PDR 71-0337

This refers to your application dated March 16, 1979 requesting approval of your Quality Assurance (QA) program as meeting the QA program requirements of 10 CFR §71.51.

QUALITY ASSURANCE PROGRAM ORGANIZATION CHART FOR

Calumet Testing Services, Incorporated  
(Name of Licensee)

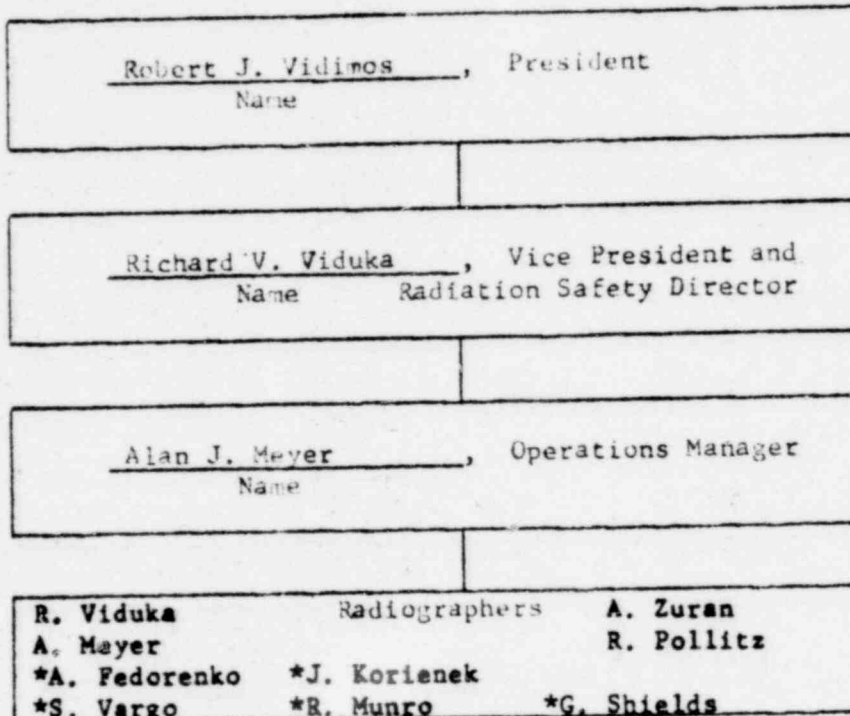
In connection with our review, we need the organization chart identified in Section 1 of the submitted QA program. Please submit seven copies of the organization chart (including the Radiation Safety Officer and the Radiographers) within 30 days following receipt of this letter.
